ARDEN SENIOR LIVING CENTER

SITE DEVELOPMENT PLAN

ARDEN SENIOR LIVING CENTER
SITE DEVELOPMENT PLAN
ROLESVILLE, NORTH CAROLINA

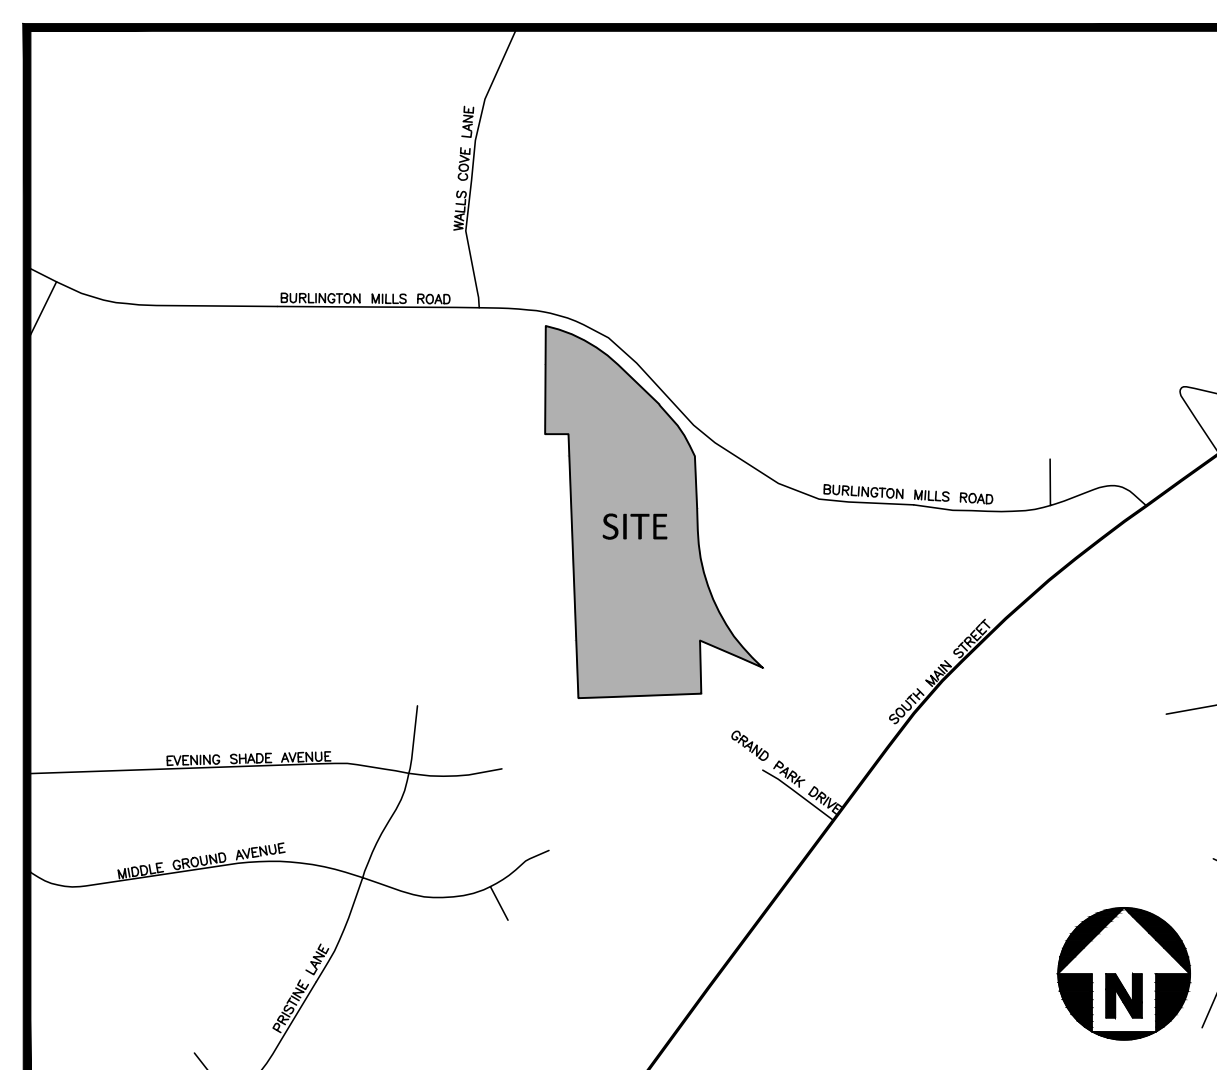
Provide site address number.

Add case number SDP-24-01 to the cover sheet.

Correct zoning to Residential High (RH) Density

Include open space breakdown by passive, active, and type required and provided.

Please list the Text Amendment case number here.

What community plan is the applicant referring to?

To the SITE DATA TABLE, please include the following information:

Setbacks Required, Bicycle Parking Data (one space per 5 dwelling units for a maximum of 30 spaces), Tree Coverage Data, Building Height, and Building Square Footage(s) and/or residential density and unit data per housing type

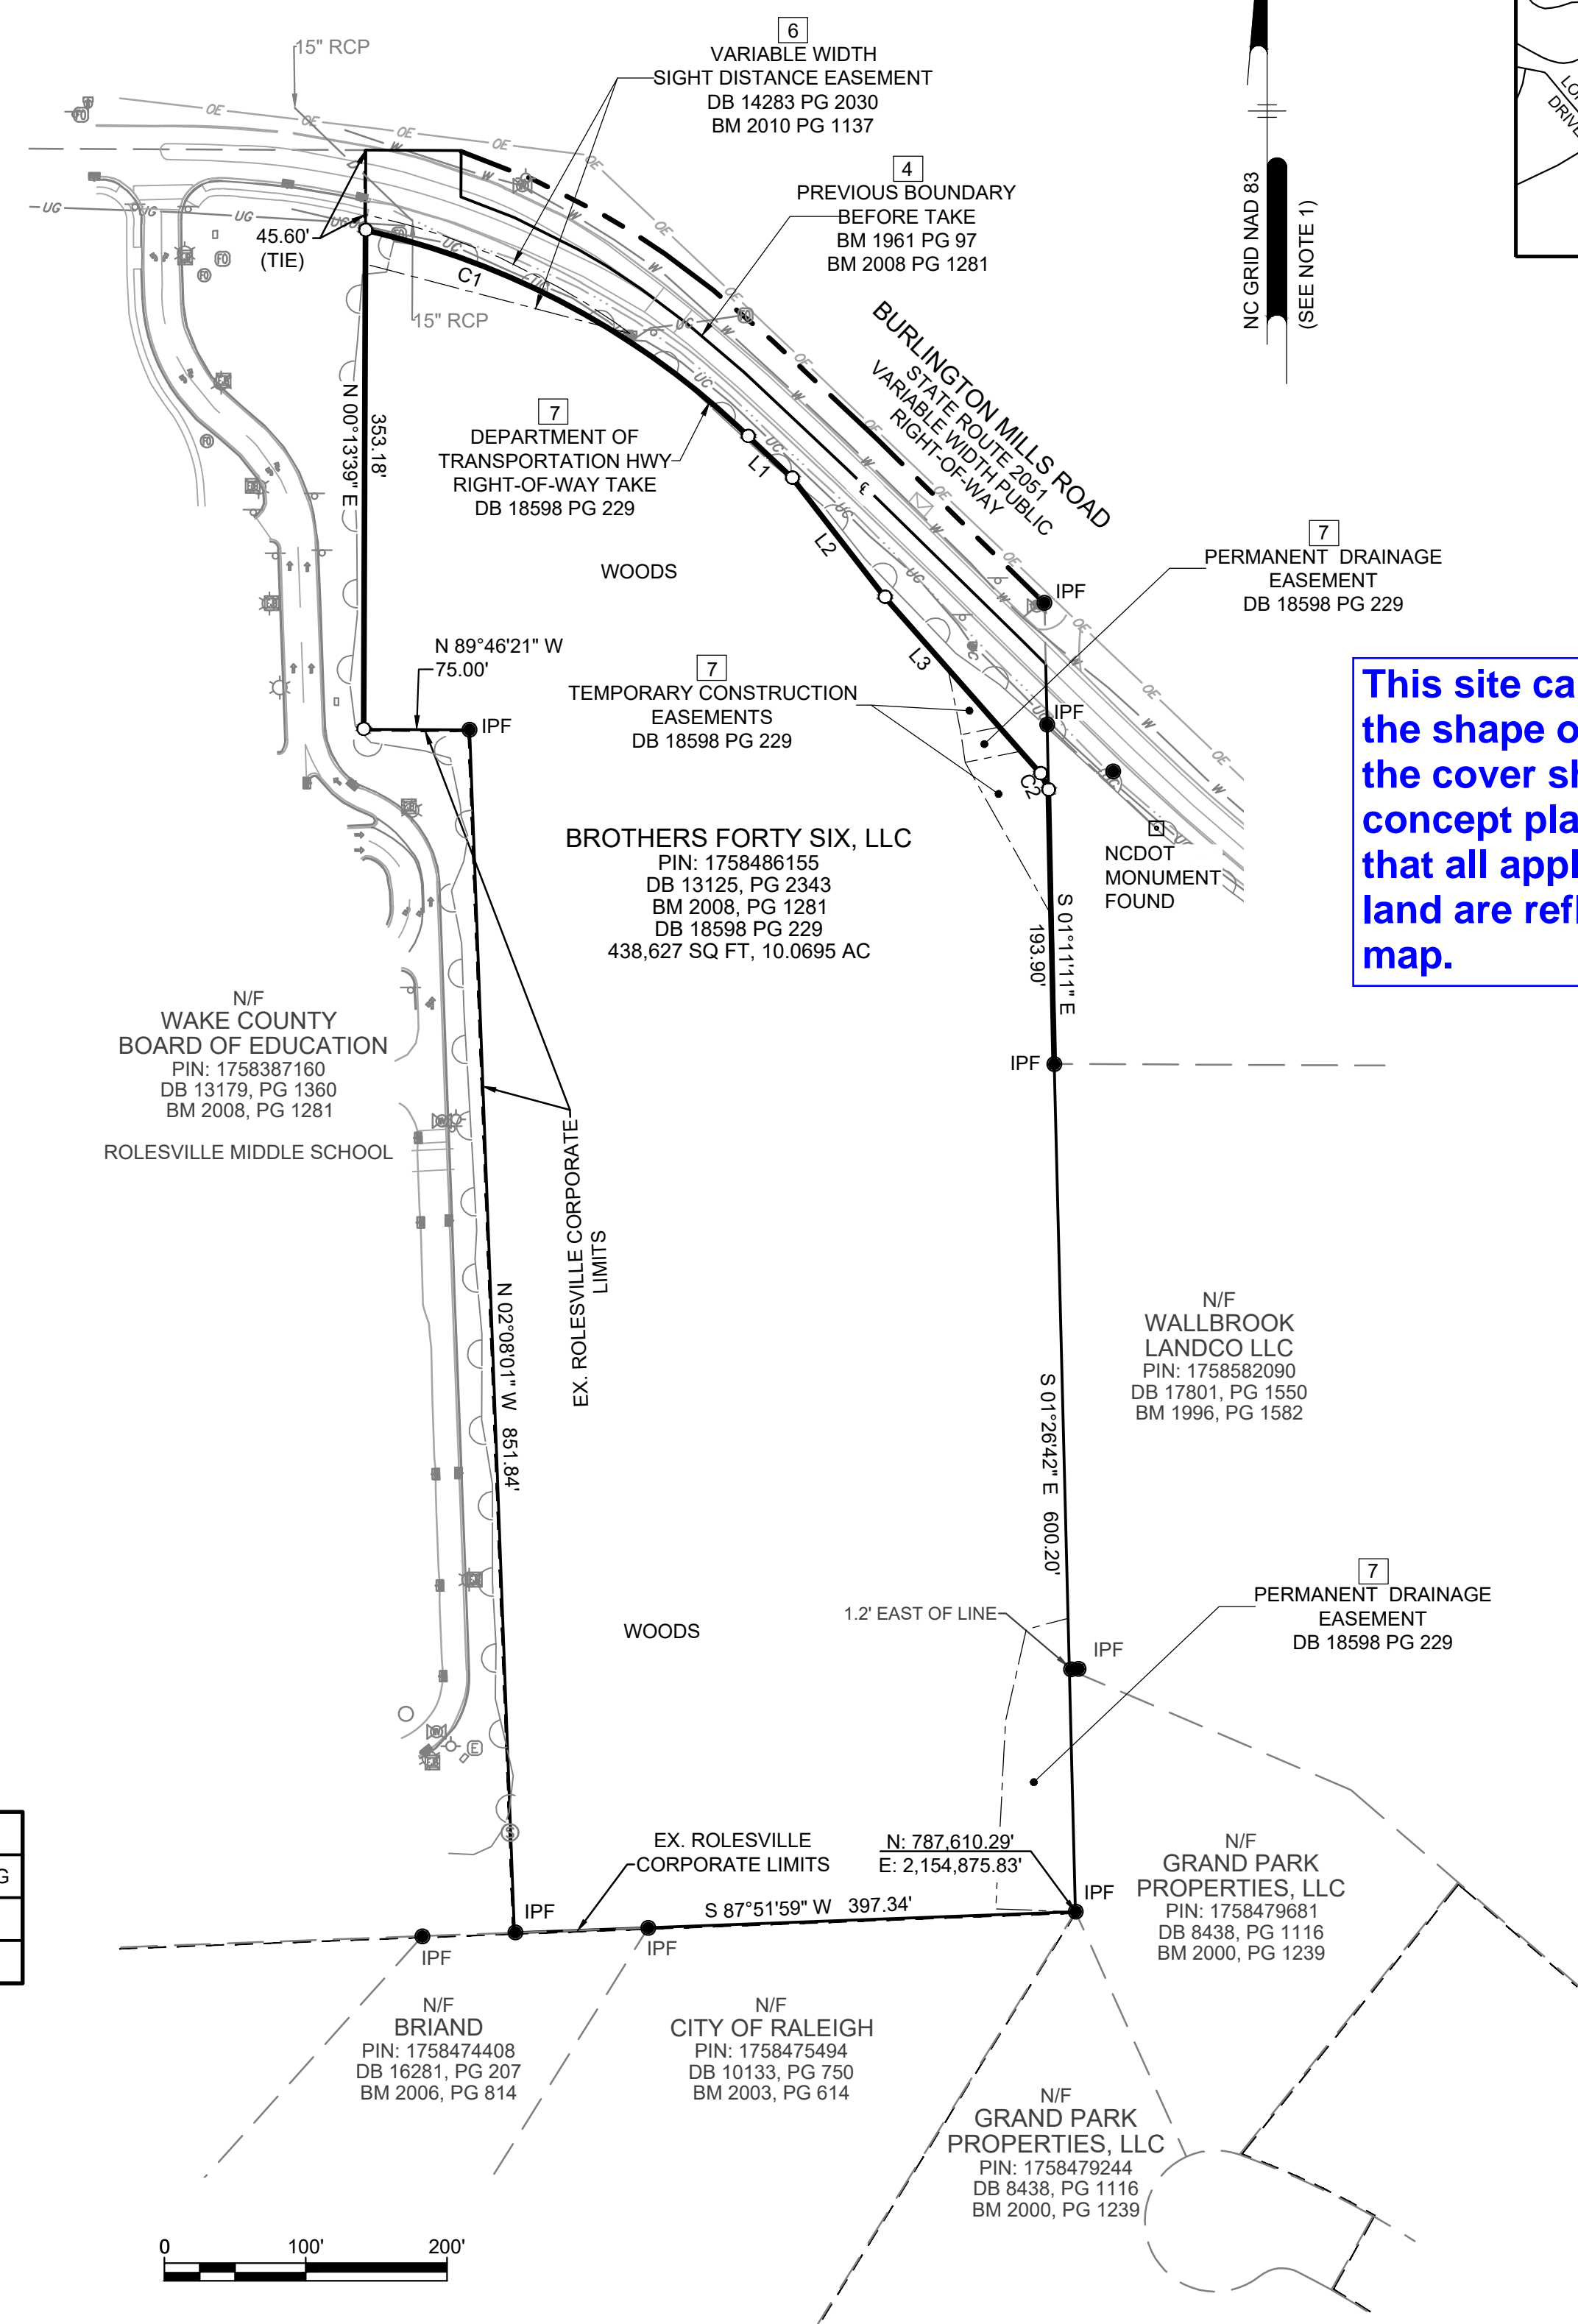
Please label the following on the existing conditions sheet:
 - Zoning districts (of site and adjacent properties to confirm buffer requirements)
 - Existing vegetation (with general description and location)
 - Topographic contours, contours shall extend 100' past property limits.
 - Water features (name and location), stream buffers, drainage ways, wetlands, and other environmental features.

This site call out differs from the shape of the site shown on the cover sheet as well as the concept plan. Please ensure that all applicable parcels of land are reflected on the vicinity map.

OVERALL SITE PLAN

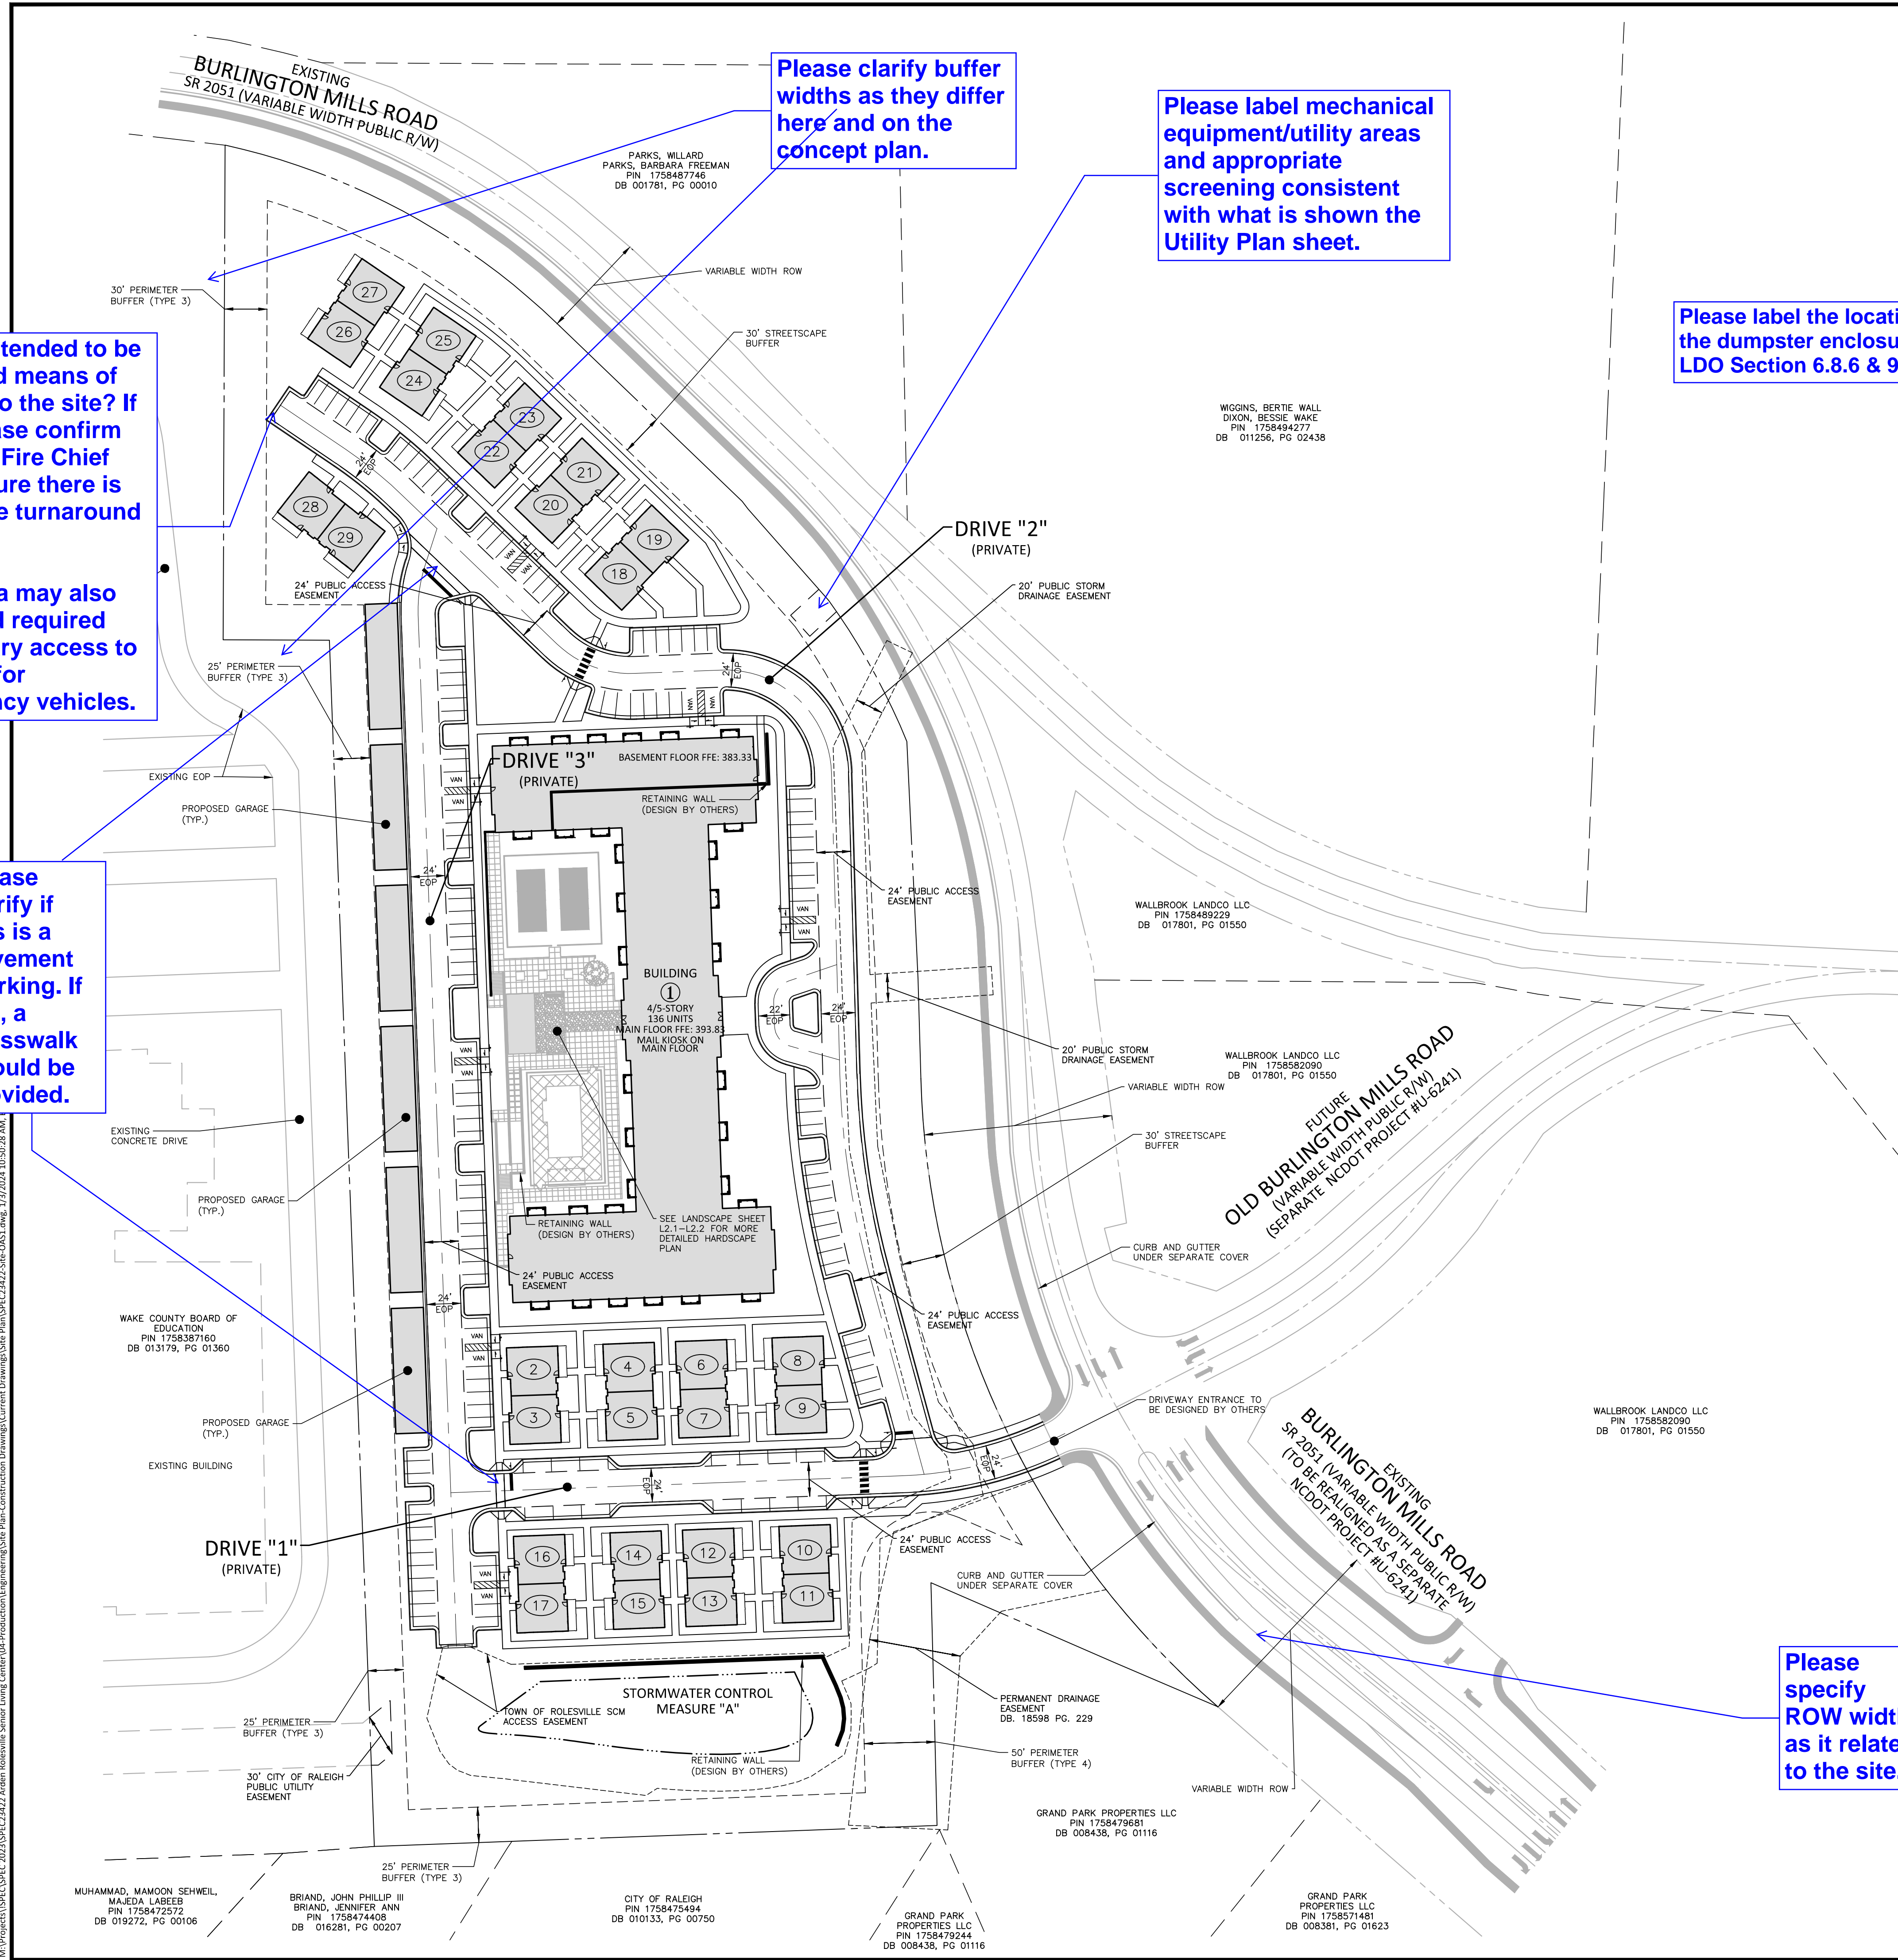
Please label mechanical equipment/utility areas and appropriate screening consistent with what is shown the Utility Plan sheet.

Please label the location of the dumpster enclosure(s). LDO Section 6.8.6 & 9.2.7

Please clarify buffer widths as they differ here and on the concept plan.

Please specify ROW width as it relates to the site.

Is this intended to be a second means of access to the site? If not, please confirm with the Fire Chief and ensure there is adequate turnaround width.

Please clarify if this is a pavement marking. If not, a crosswalk should be provided.
